Response to Requests for Additional Information for the Review of the ARCADIA[®] Reactor Analysis System for PWRs Methodology Description and Benchmarking Results Topical Report

ANP-10297Q1NP
Revision 0

AREVA NP Inc.

Figure 31-A-1: Boron Differences

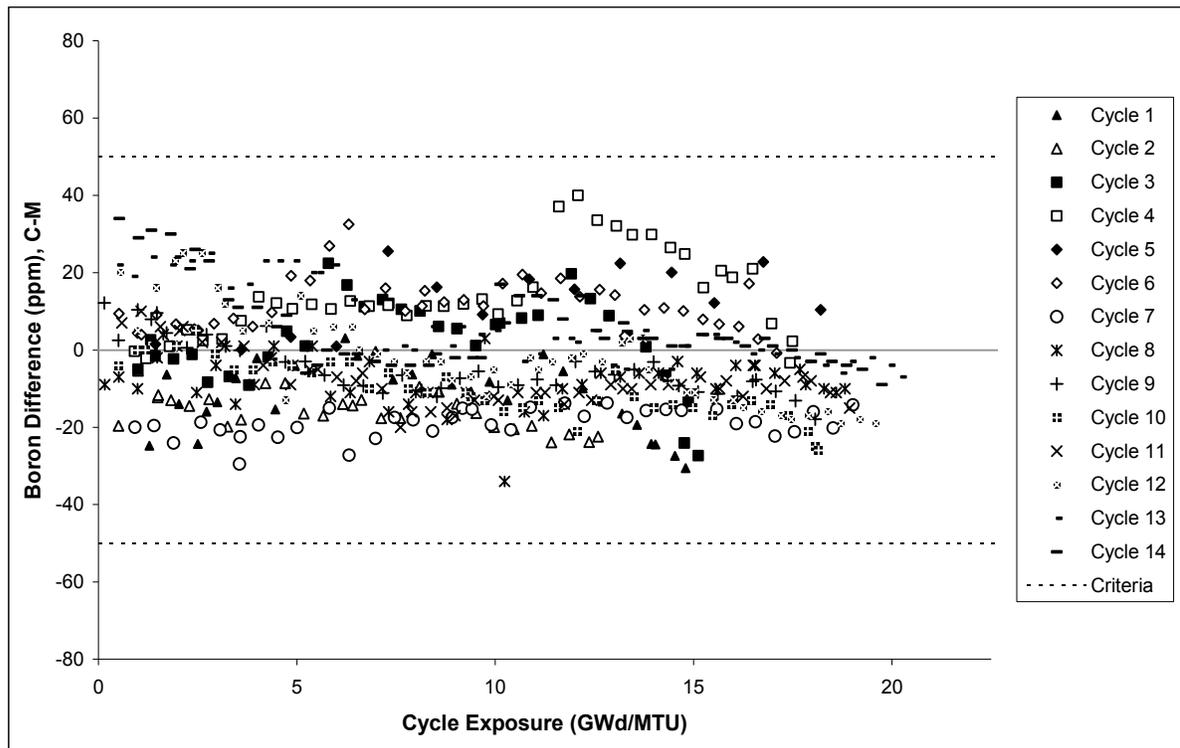
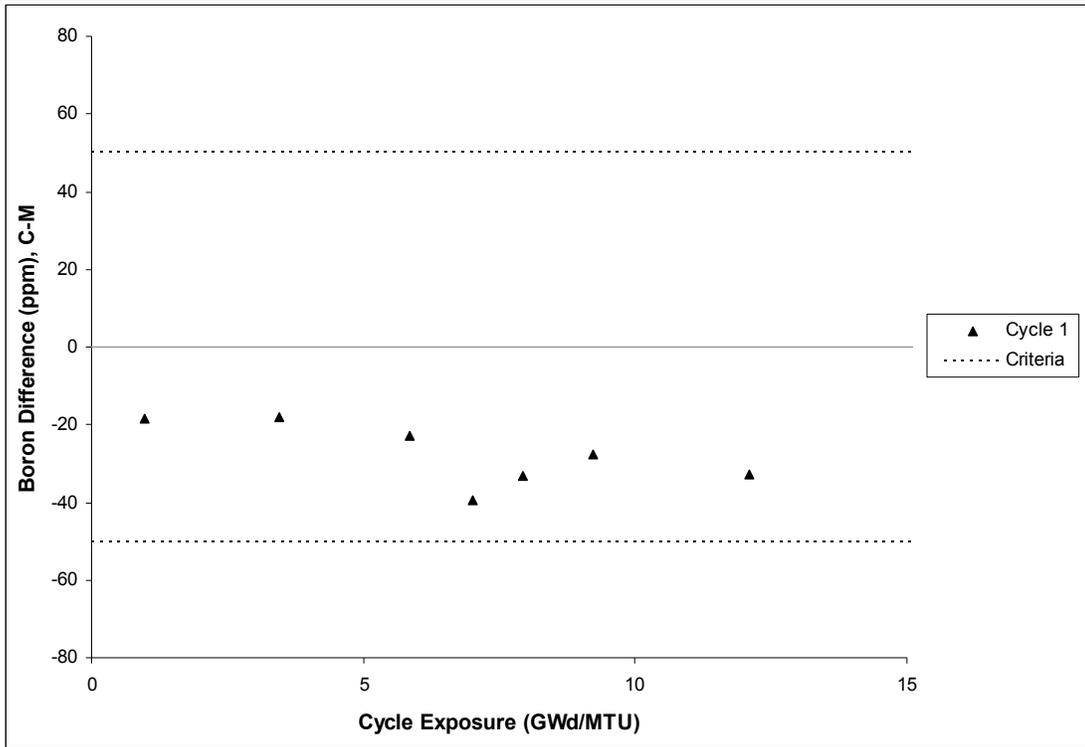
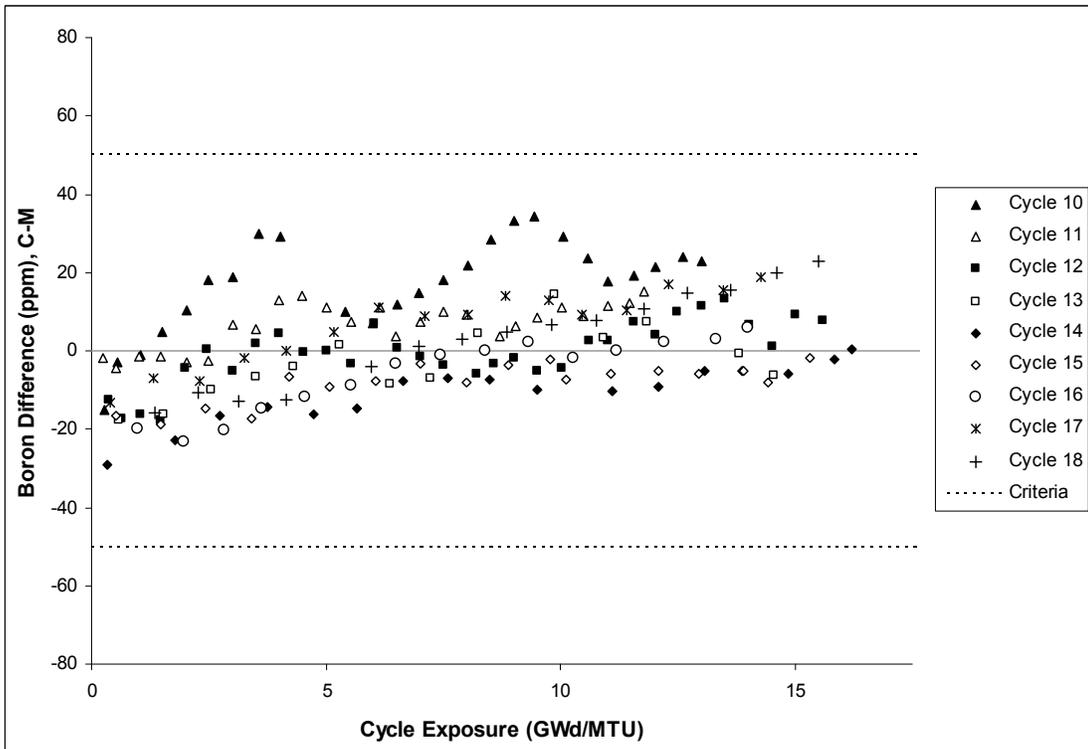
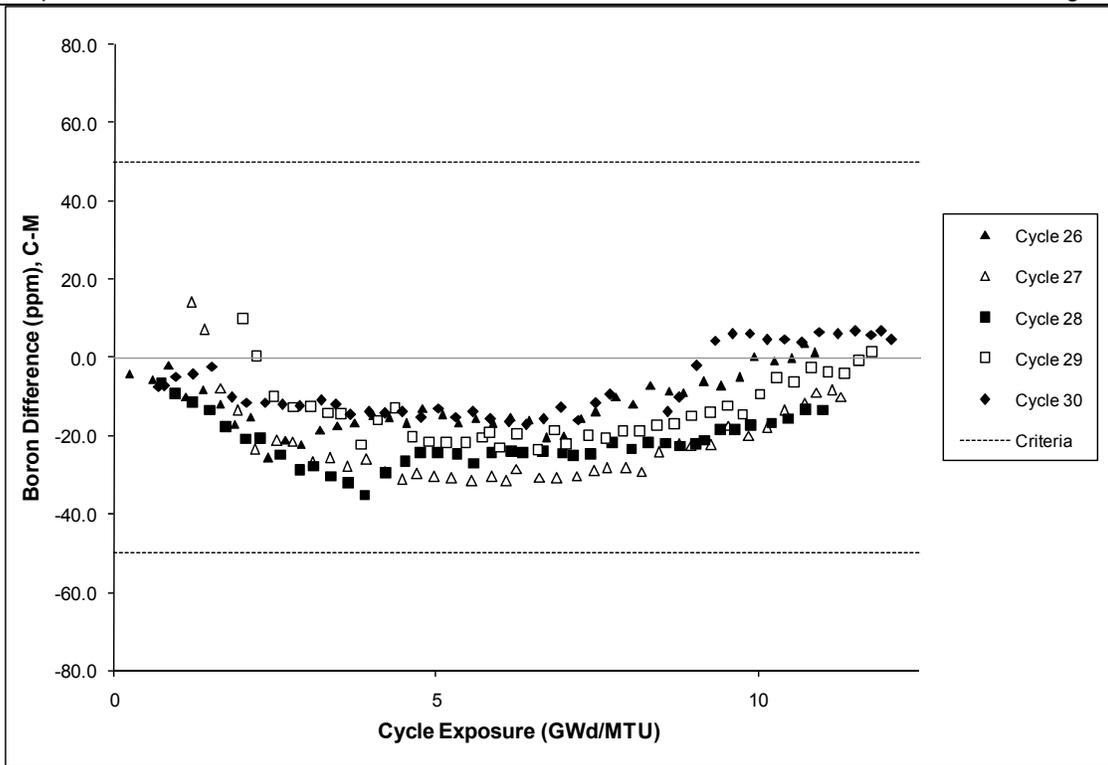
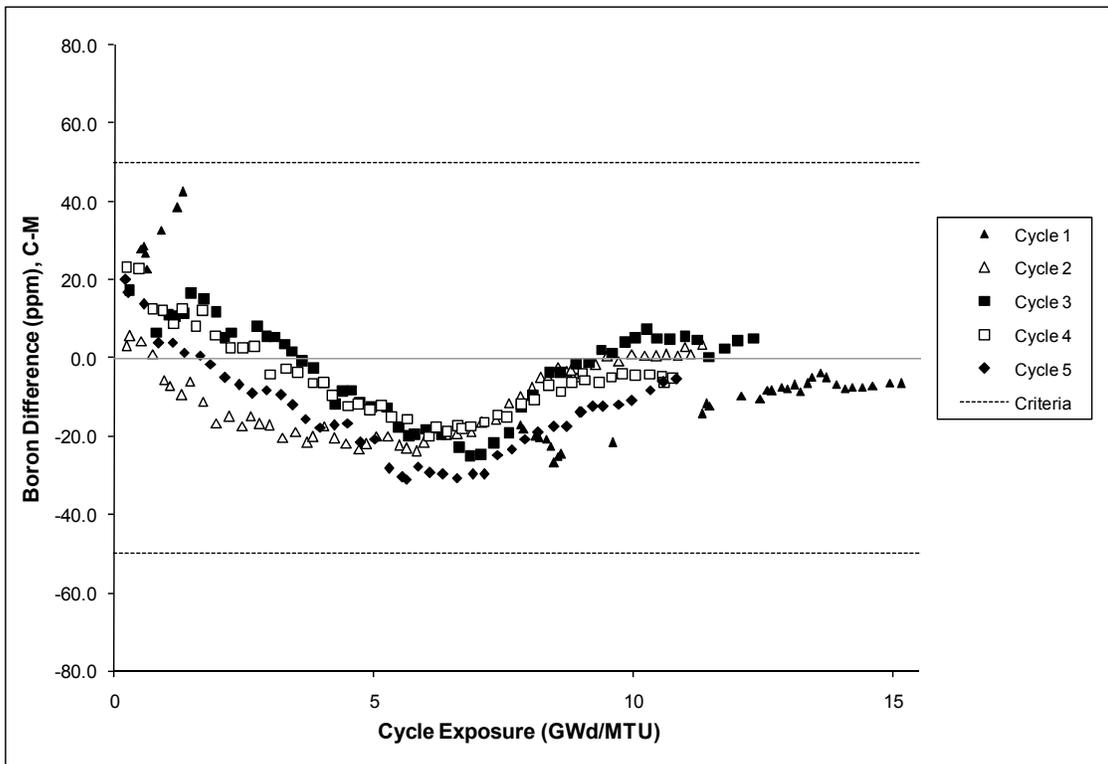
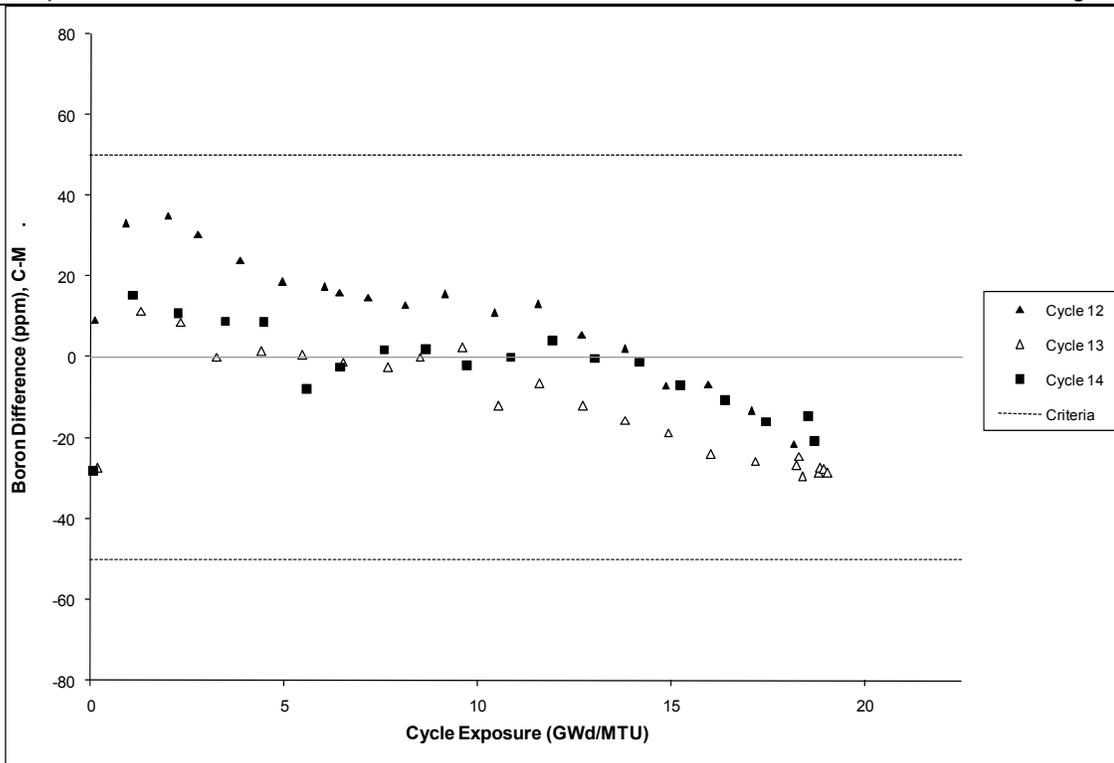
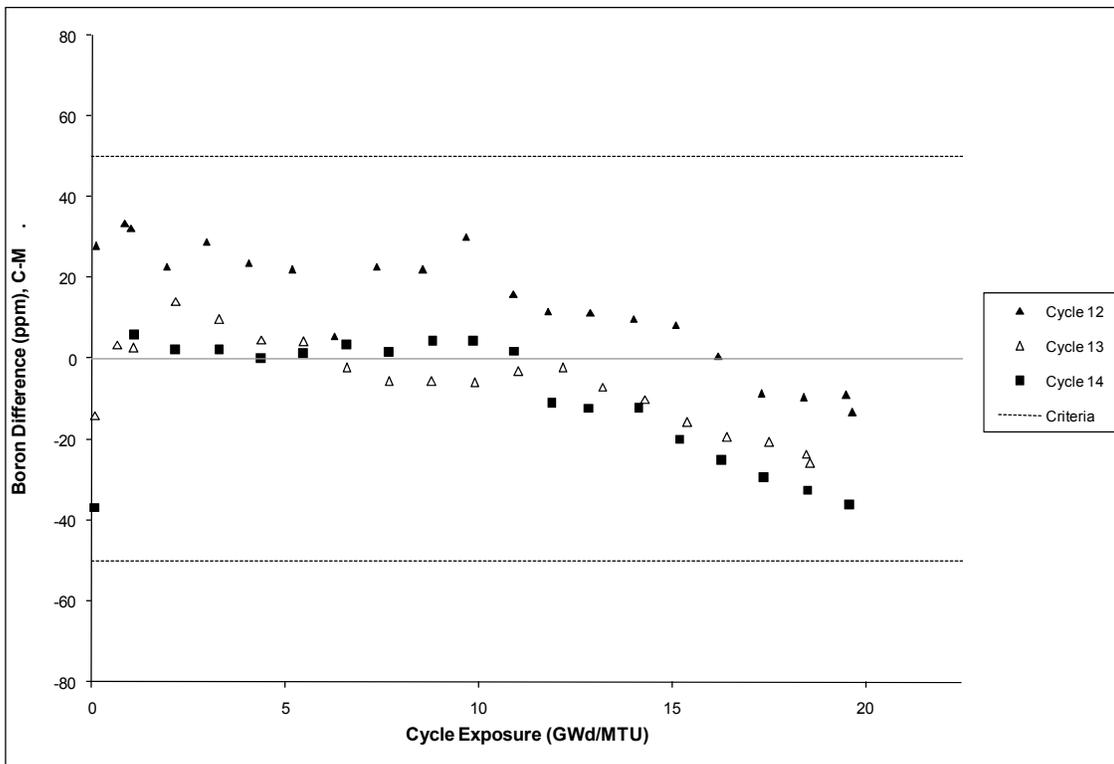
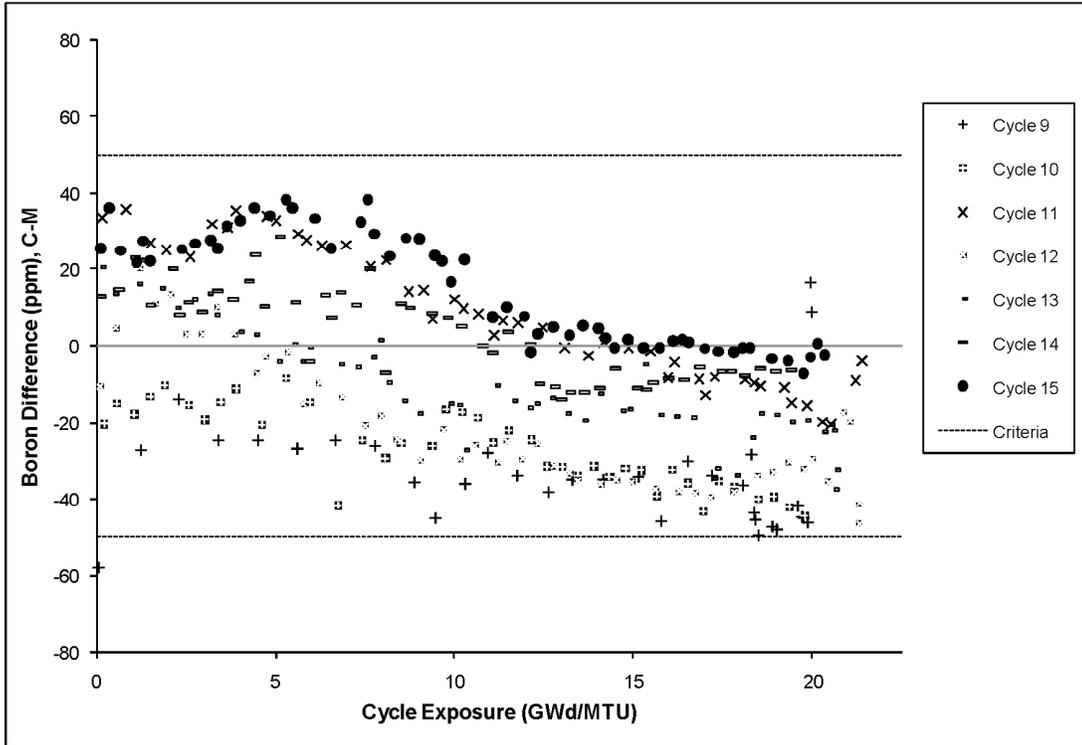
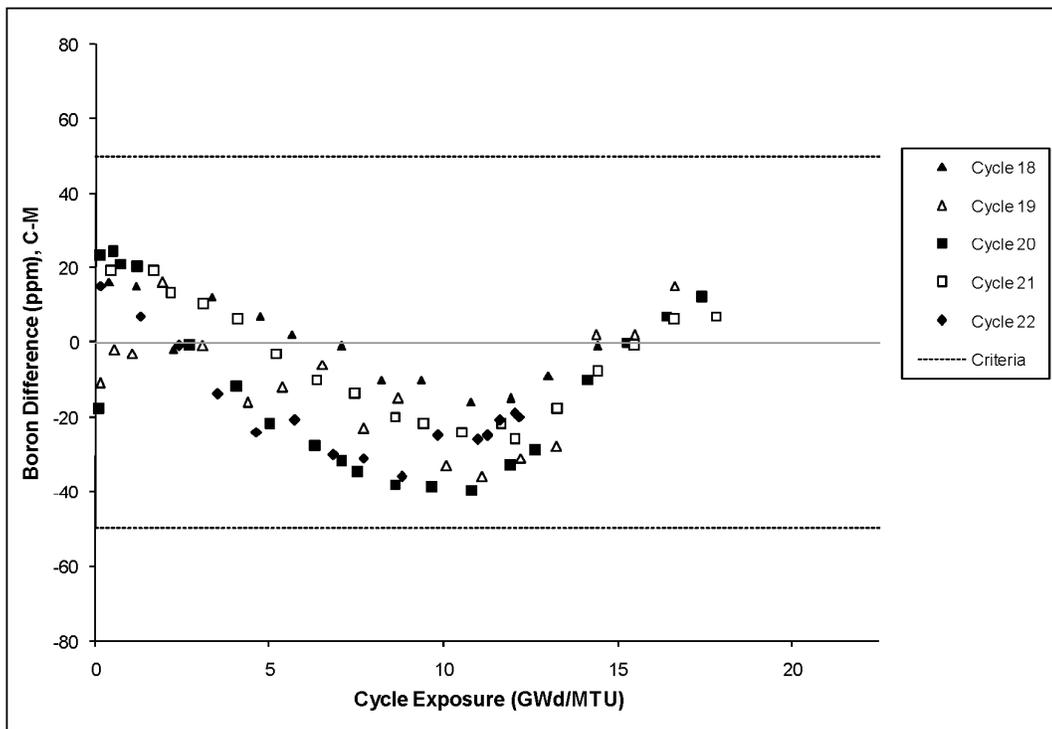
RAI 31 The boron letdown curves are presented for each cycle individually as a function of fractional cycle length. This scale is confusing because it prevents some comparisons from cycle to cycle, and inhibits the ability to approximate cycle length-based effects, such as gadolinia depletion, B-10 depletion, and design implications for 24 vs 12 month cycles, etc. Furthermore, the letdown curves are presented on an absolute value scale, which makes individual deviations very hard to discern. A summary plot of boron difference for all cycles (to compare against each other, potential by plant), plotted versus a non-relative scale such as cycle exposure would be useful. [Page A-9+]

Summary plots of the boron deviations are provided. These plots use an absolute scale for burnup and present the boron deltas for all cycles by plant.
